SERVICE BULLETIN	
Service Bulletin #	JSA-008
Superseded Bulletin #	
Issue Date	12/01/2011
Effective Date	12/01/2011
Limitations for Completion	At Next 100 hour or Annual Service
Make & Model Affected	J170-SP Serial # 75 thru # 207
Page 1 of 2

SERVICE BULLETIN: **JSB 029-1**

Subject: **J170 Handling Upgrade**

Figure 2 – New Rudder Centring Springs

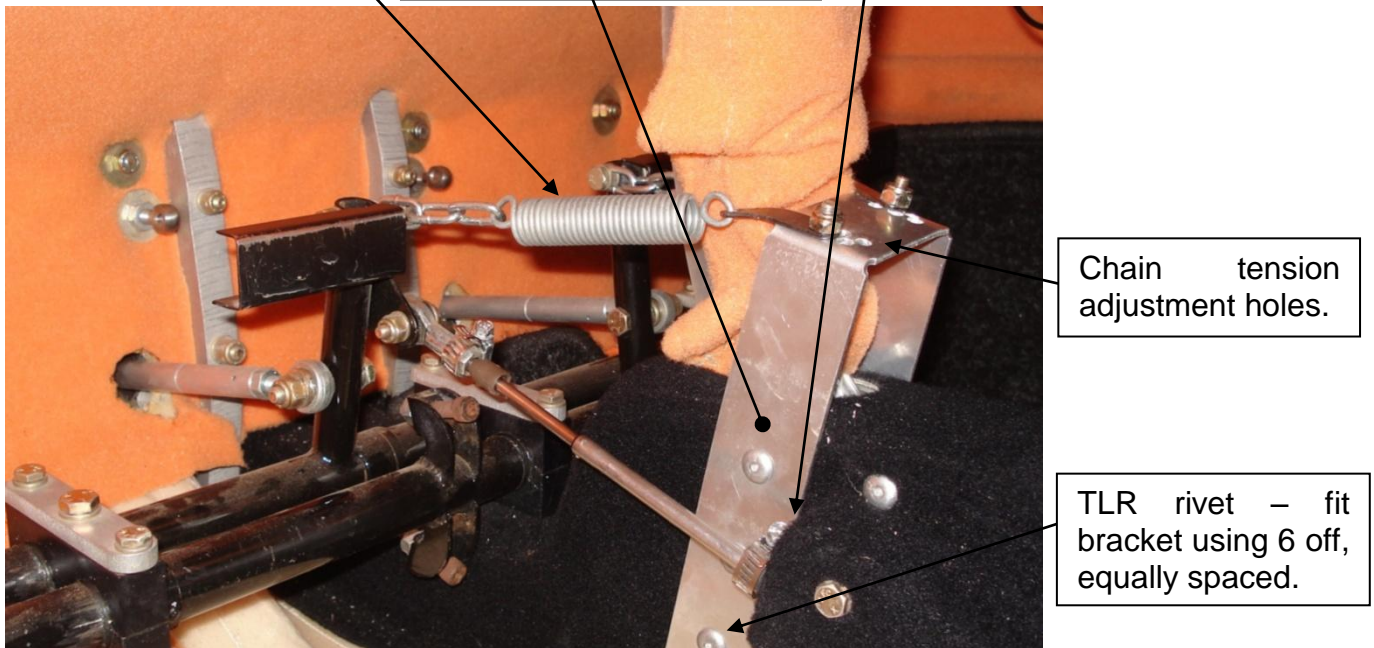
- Remove the existing rudder springs and chains from the rudder pedals.
- Fit the new spring mounting bracket to the aircraft's centre console using 6 off TLR rivets as shown in Figure 2. The exact position is not critical – but it should be aligned with the front of the rudder cable mount and positioned so that the chains and springs run as straight as possible.

- Fit the new springs as shown in Figure 2. Adjustment of these springs is important for correct handling of the aircraft. The springs must be set so that when the rudder pedals are centered neither spring is carrying any load – but as soon as the pedals move slightly a spring takes up tension. If the springs are set too tight – i.e. when the pedals are centered both springs are carrying some tension – this will reduce the centring effect of the spring system and must be avoided. If the springs are set too loose the pedals must move too far before there is any centring effect – this makes the system ineffective near centre and must also be avoided.

New rudder centring spring & chain assembly

Spring anchoring bracket – rivet to centre console

Align rear of bracket to front of rudder cable mount

Figure 3 – Fitting Adaptor to Drive Arm

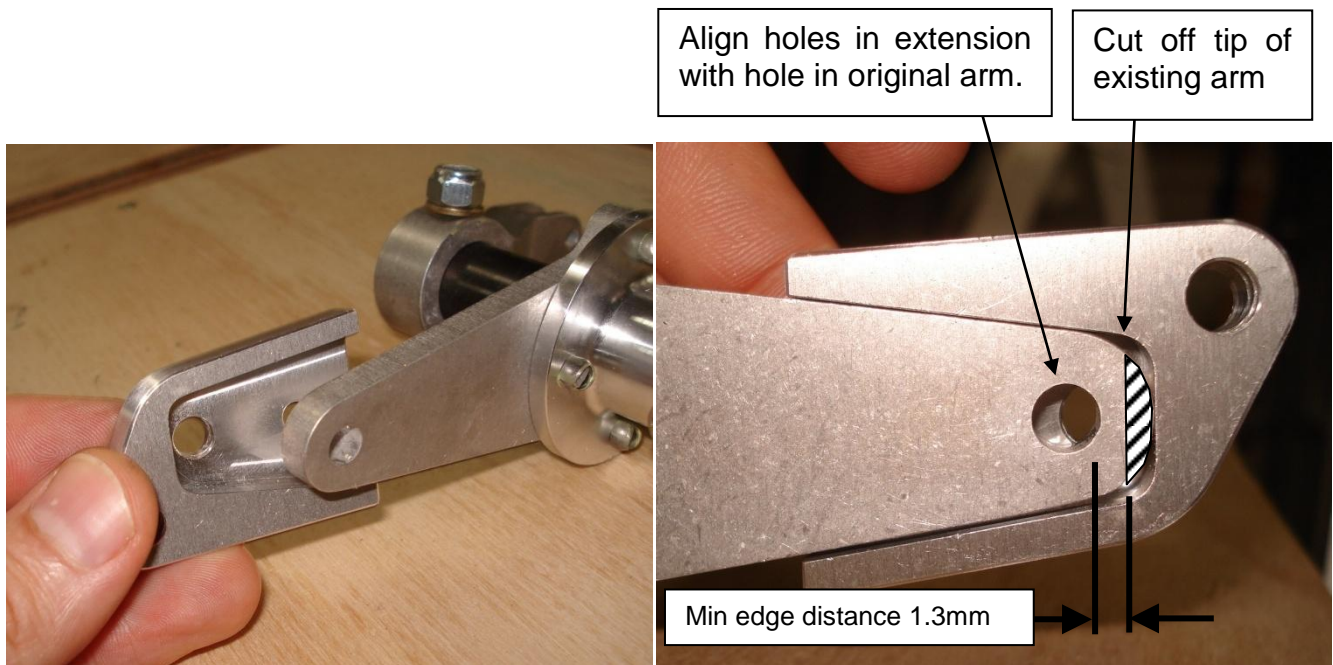
- Apply the new drive adaptor to the existing internal flap drive arm from the outboard side – it will be obvious how much material must be removed from the existing arm to fit the adaptor. Figure 3 (right) shows this. Carefully remove this material, removing just enough so that the extension slides onto the arm far enough to align the bolt holes and to fit snugly around the arm. De-burr the tip. Note the minimum edge distance shown in Figure 3 (right).

- The adaptor can now be placed on the inboard side of the flap drive arm and used as a guide to drill the new 3/16” hole. Carefully drill through the hole on the adaptor and through the existing drive arm.

Figure 4 – Adaptor in Place

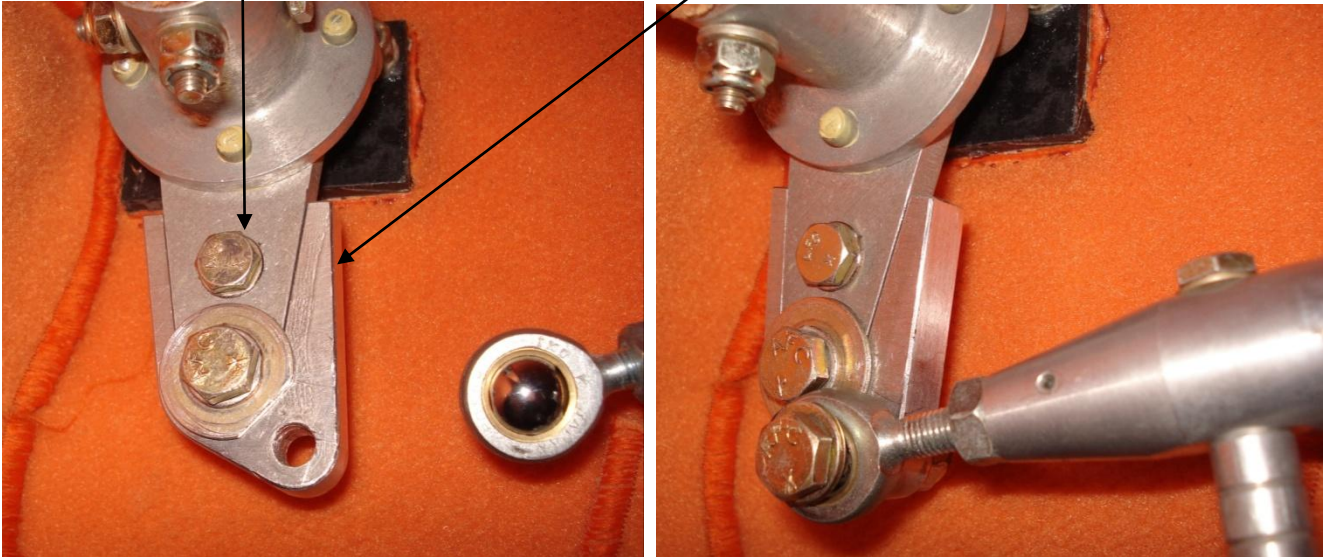
- Remove the adaptor from the drive arm. Clean it using Acetone. Mix and apply 5-minute epoxy resin to its socket.
- Bolt the adaptor to the arm using 1 off ¼” and 1 off 3/16” bolts, orienting it as shown in Figure 4. Wipe off any excess resin. Both bolts can be fitted from the cabin side of the drive arm – care will be needed to use the correct length bolt so that the tails of the bolts do

Use the 3/16" hole in the adaptor as a guide to drill a matching hole in the existing arm

Adaptor bolted & bonded in place. Use of penny washer is optional.

Figure 5 – Flap Drive Modification

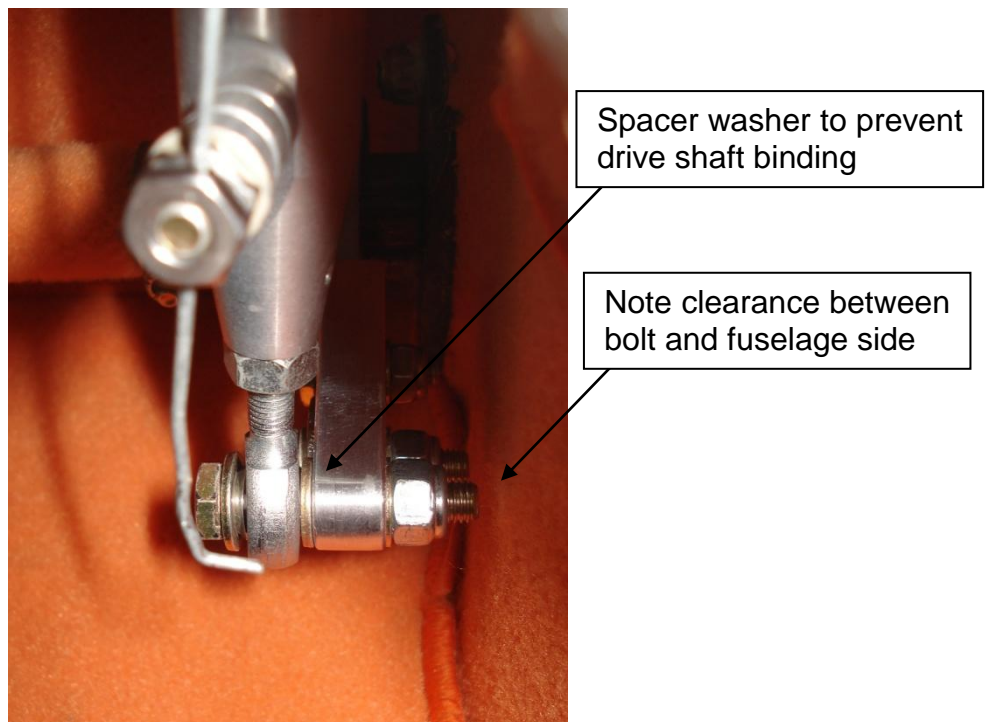
- Turn the aircraft master power on and drive the motor to the fully “down” position, then turn the master power off.
- Once in position, adjust the rod end in the motor shaft to align with the lowest hole in the adaptor and re-connect it using a ¼” bolt. Note that if there is not enough adjustment in the rod end the external flap drive pushrods can be adjusted to suit. Again, AN363 or MS21042 nuts may be used if required to give clearance from the fuselage.

- Remove the tape or stands from the flaps.
- Turn the aircraft master power on and cycle the flaps, checking for smooth operation with no binding or other issues. Measure the flap deflection – between full up and full down positions the flaps must travel $30^{\circ} \pm 1.5^{\circ}$.

Figure 7 – New Ventral Fin Fitted

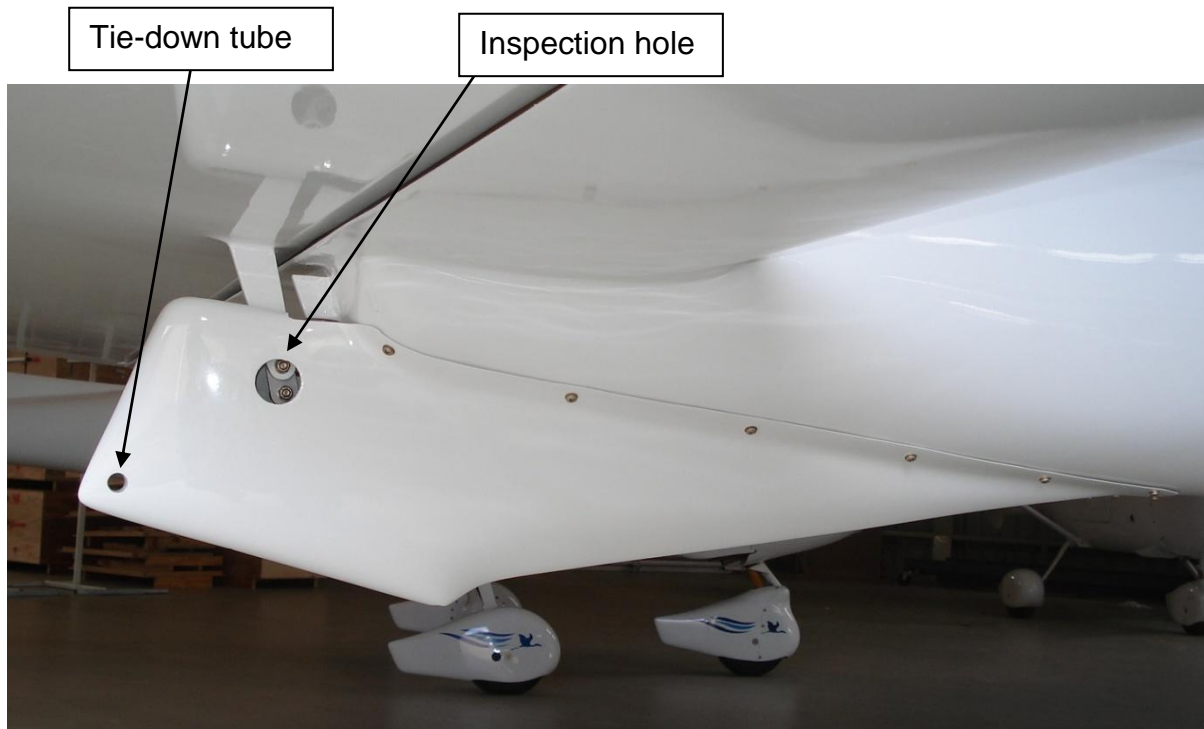
- Remove the existing ventral fin and weigh it accurately.
- Cut the inspection hole and fit the tie-down tube to the new ventral fin. Drill two ¼” drain holes in the bottom of the fin at the positions indicated in Figure 7. Paint to match the aircraft.

- Match drill the replacement fin mounting screw holes to the original part. Note that although the replacement fins are supplied with pilot holes drilled the exact hole positions must be found by comparison to the original parts.

- Weigh the replacement fin accurately.
- Fit the new fin.
- Some J170 aircraft operate quite close to the rear of their CG envelope and in some cases the extra weight added by this new ventral fin will be sufficient for the aircraft to exceed its rear CG limit in some load cases. Operators must calculate the effect that changing this part has had on their aircraft and assess if any ballast or operating changes are required. Depending on the category in which the aircraft is operating these calculations may need to be carried out by an approved Weight Control Authority.
